APPENDIX C

RESPONSE TO AGENCY COMMENTS
ON THE DRAFT FINAL REPORT

RESPONSE TO COMMENTS ON THE
DRAFT FINAL TRACK 1 ORDNANCE AND EXPLOSIVES
REMEDIAL INVESTIGATION/FEASIBILITY STUDY
FORMER FORT ORD, CALIFORNIA
DATED JUNE 2003

- I. JOHN D. CHESNUTT, REMEDIAL PROJECT MANAGER, UNITED STATES ENVIRONMENTAL PROTECTION AGENCY, REGION IX, 75 HAWTHORNE STREET, SAN FRANCISCO, CALIFORNIA 94105, COMMENTS DATED JULY 11, 2003

**Site Walk
Site OE-66
November 13, 2003**

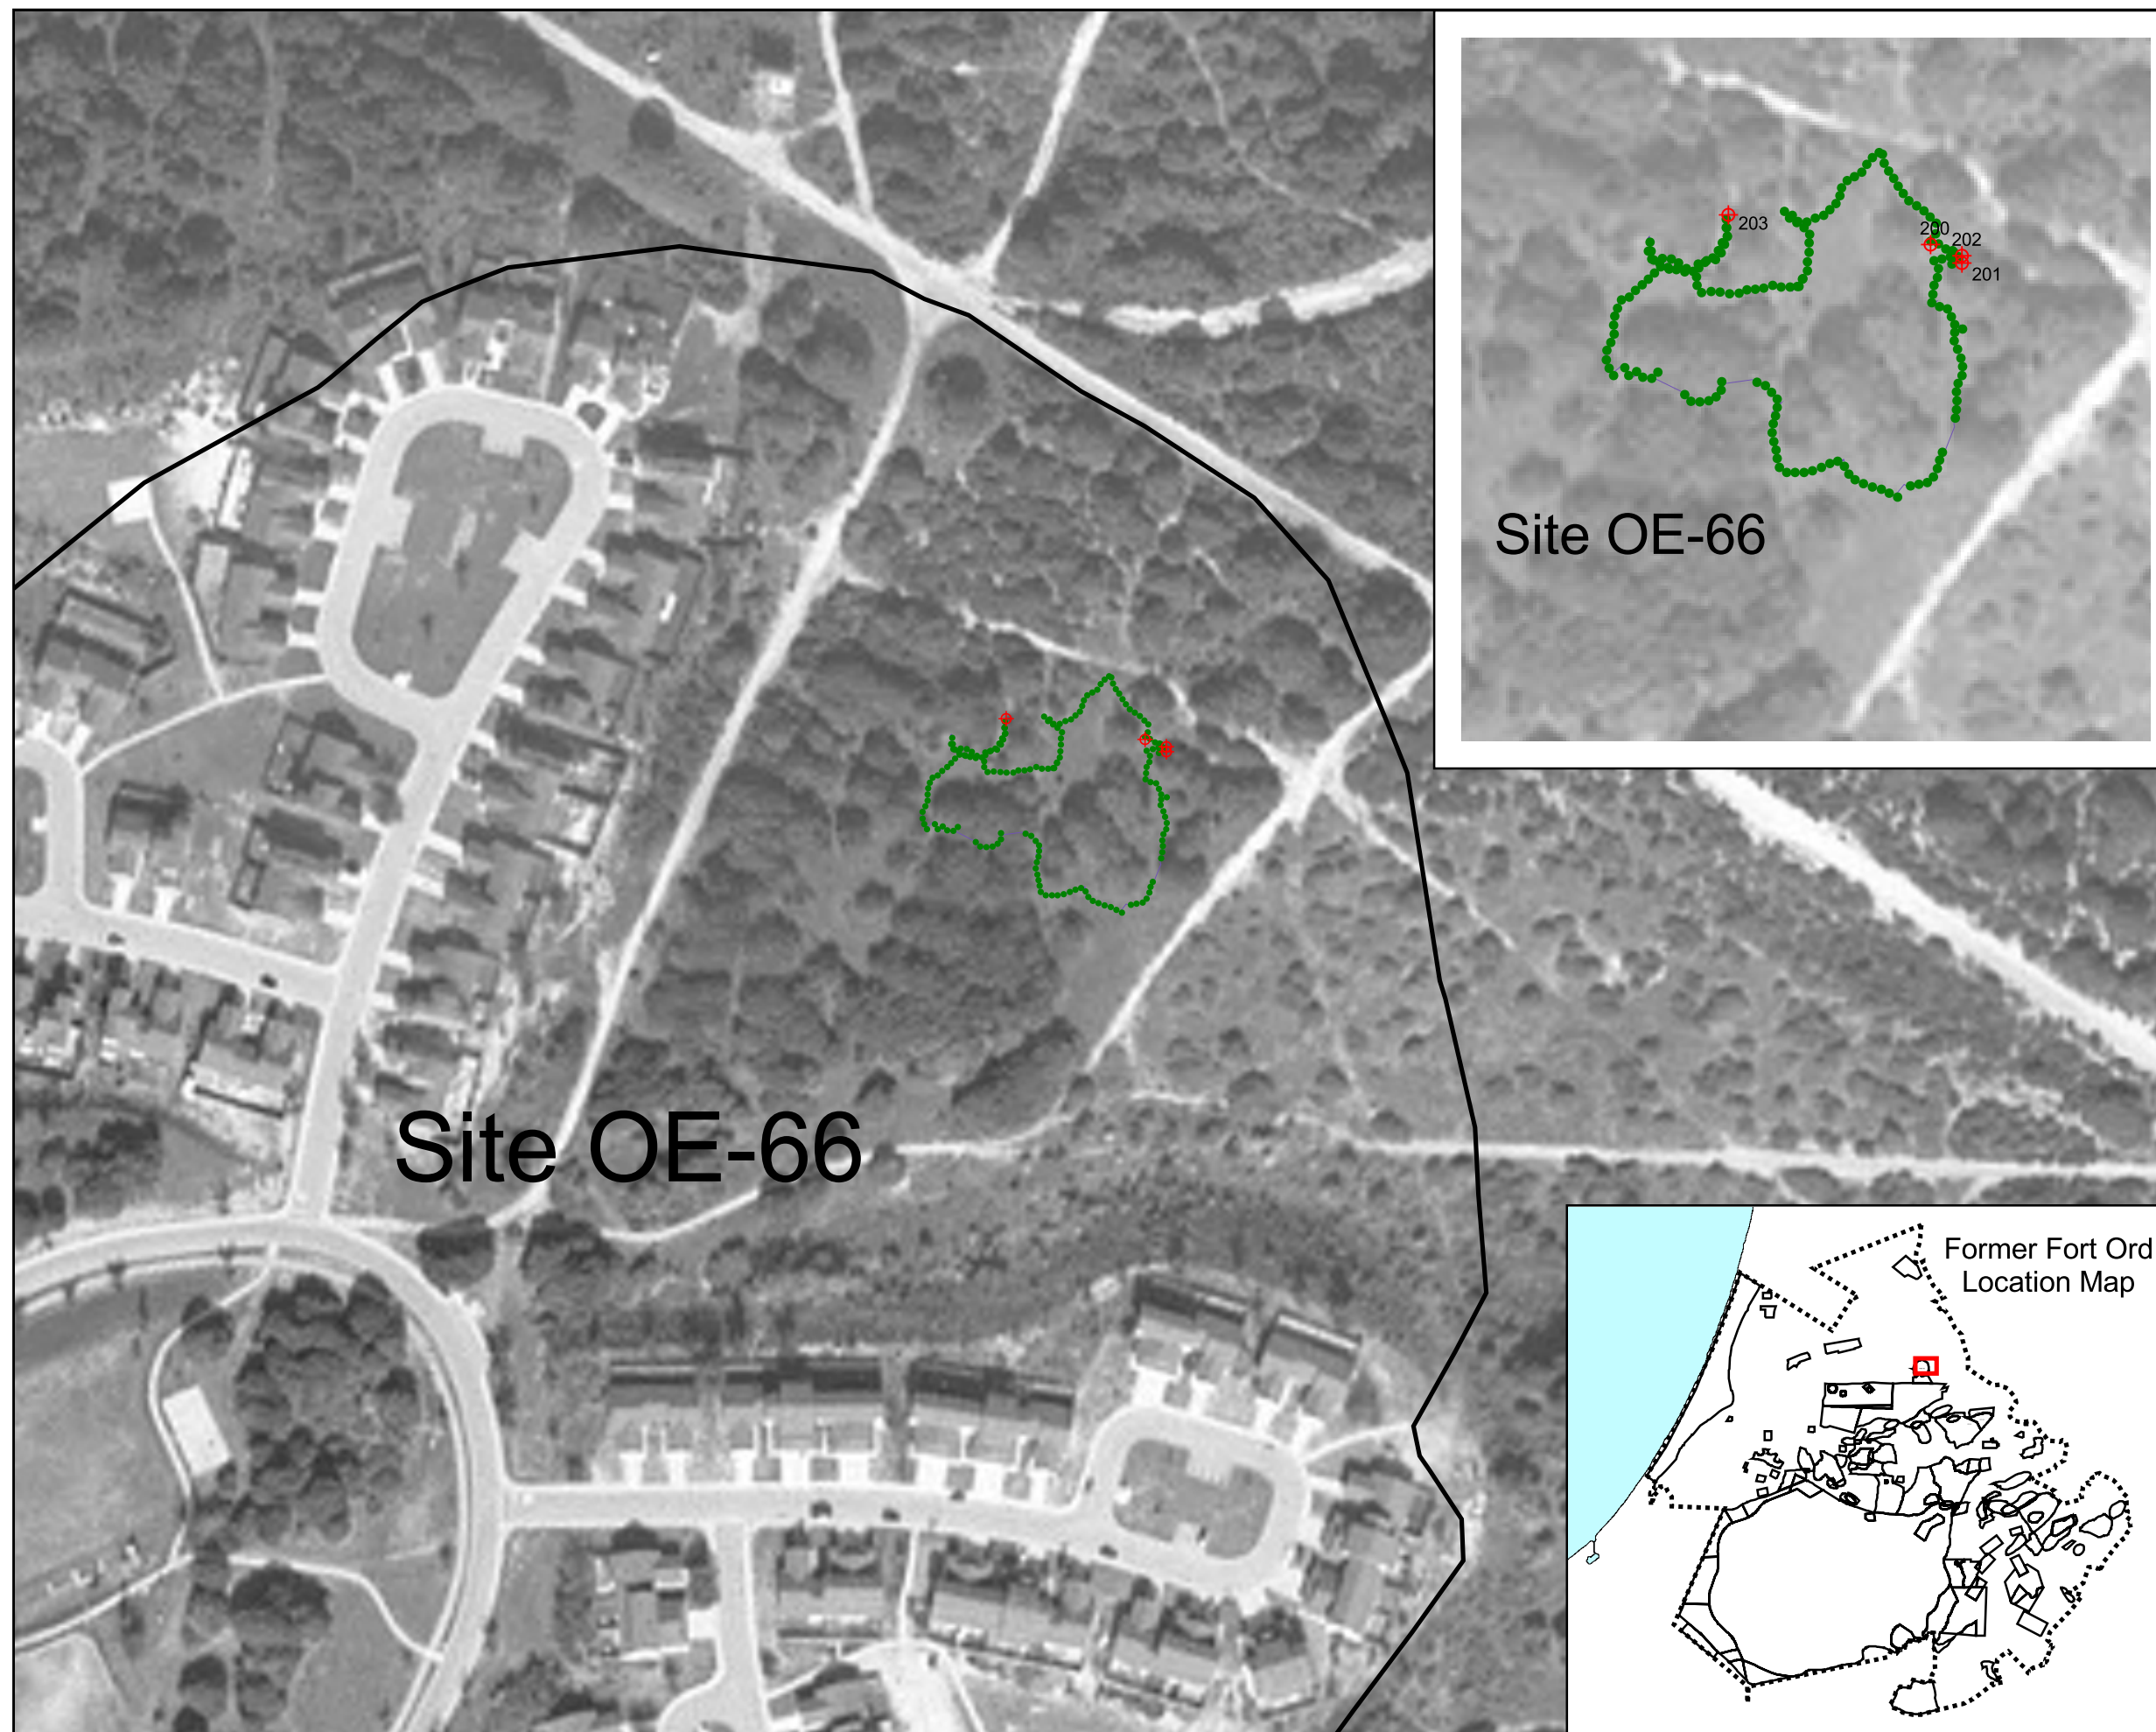
Comment 27: **Site OE-66 (Signal Corps Small Arms)**

Response 27: Additional investigation of this site was conducted in November 2003 (site walk). The text has been revised to include the results of the site walk and a report documenting the site walk is included as an attachment to this Appendix. The results of the site walk support the recommendation that no further OE-related investigation is necessary at Site OE-66.

**Site Walk
Site OE-49
March 7, 2004**

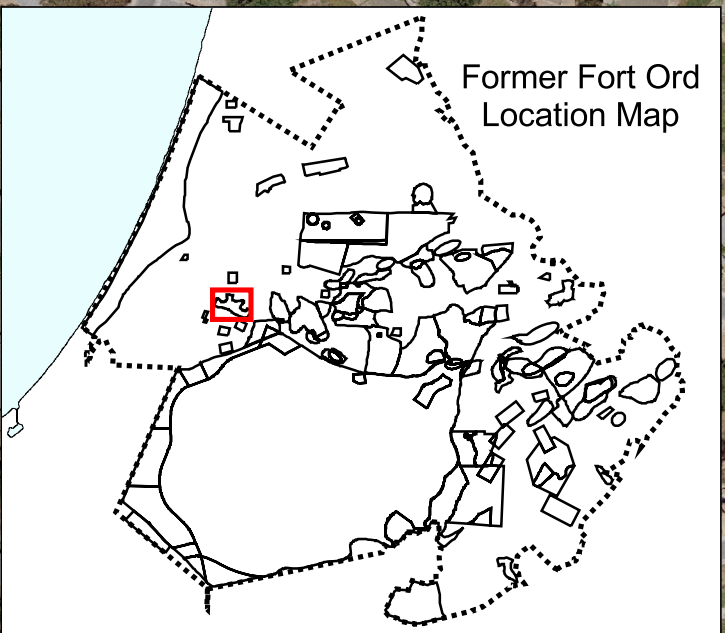
The designation of this site as Track 1 cannot be supported without additional data. The information describing the activities conducted in the area, the source and credibility of the information resulting in the designation of an unspecified portion of the area as a rifle grenade range, and the potential OE used in the area have been substantially expanded. However, the information provided affords insufficient assurance that HE rifle grenades were not used inside the site boundaries. No intrusive sampling has been done, and the reconnaissances conducted appear to have left significant portions of the site unobserved. As a result, the Army needs to propose an acceptable procedure to the regulatory agencies to resolve this situation. An intensive reconnaissance of the area, with discussion of the results, would be of value in determining how to proceed. Until an acceptable process for documenting that no rifle grenade related OE remains on the site, it cannot be supported for designation as a Track 1 site.

Response 23: A follow-up investigation of this site (site walk) was conducted in March 2004. The Final Track 1 OE RI/FS will include the results of the site walk, and a report documenting the site walk is included as an attachment to this Appendix. The results of the site walk support the recommendation that no further OE-related investigation is necessary at Site OE-49.

**SITE OE-6
SITE WALK PATH**

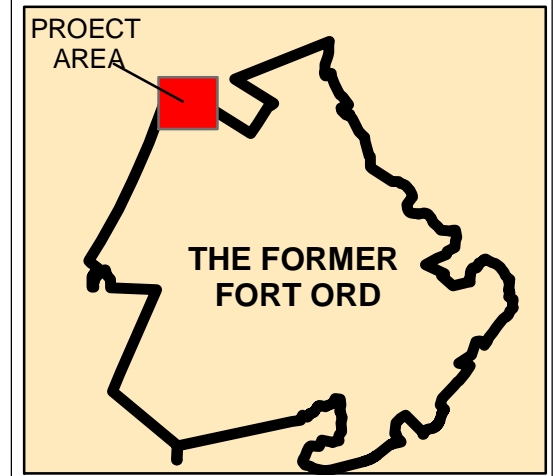
The designation of this site as Track 1 cannot be supported without additional data. Although the descriptive information concerning the sampling activities and the potential OE use within the area has been expanded significantly, the fact remains that the precise location of the OE items found during the sampling work is unknown. According to Plate 6-4, none of the sampling grids include that portion of OE-6 which overlaps the 1954 Mine and Booby Trap Area shown on that plate. This unsampled overlap area is the area of prime concern with respect to the potential presence of OE items in Site OE-6. As a result, the area of prime concern has not been sufficiently investigated to support the inclusion of Site OE-6 as a Track 1 site. Until further evidence is presented for that area, the site will remain suspect and should not be a Track 1 designee.

Response 4: No evidence was found during the literature review or during OE sampling to indicate that high explosives were used at Site OE-6 or that this site was used as an impact area. Sampling included the investigation of sixteen 100- by 100-foot grids within Site OE-6 and in the open area between Site OE-6 and nearby Site OE-1 to the south. No OE was found during this sampling. The OE scrap that was found during sampling was consistent with the type of items that were expected to have been used in training where practice or inert mines and booby traps were used (e.g., M1 antitank practice mines, M80 antitank training mines, and M8 antipersonnel practice mines). Based on the evidence gathered during the RI, the Army believes that no further OE-related investigation was warranted. However, to address regulatory agency concerns regarding the adequacy of the sampling investigation conducted at Site OE-6, a site walk was performed on June 2 and 3, 2004, within the boundary of Site OE-6 and the open area to the south of the site. To investigate this former mine and booby-trap training area, the team utilized a meandering path method for the site walk. The investigation was conducted by a two-person team that included a UXO Safety Specialist. The team swept the path walked using a Schonstedt Model GA-52/Cx magnetometer. Only OE scrap was found during the site walk. The scrap items found (two expended fuzes for M1 series practice mines and an expended firing device [M1-type]) are consistent with the type of items that would have been used at a mine and booby-trap training area and support the conclusion that no further OE-related investigation is necessary at this site. Other training related items found included a hand grenade safety lever and live and expended small arms

ammunition. Details of the site walk including a map showing the path walked are included as an attachment to this appendix.
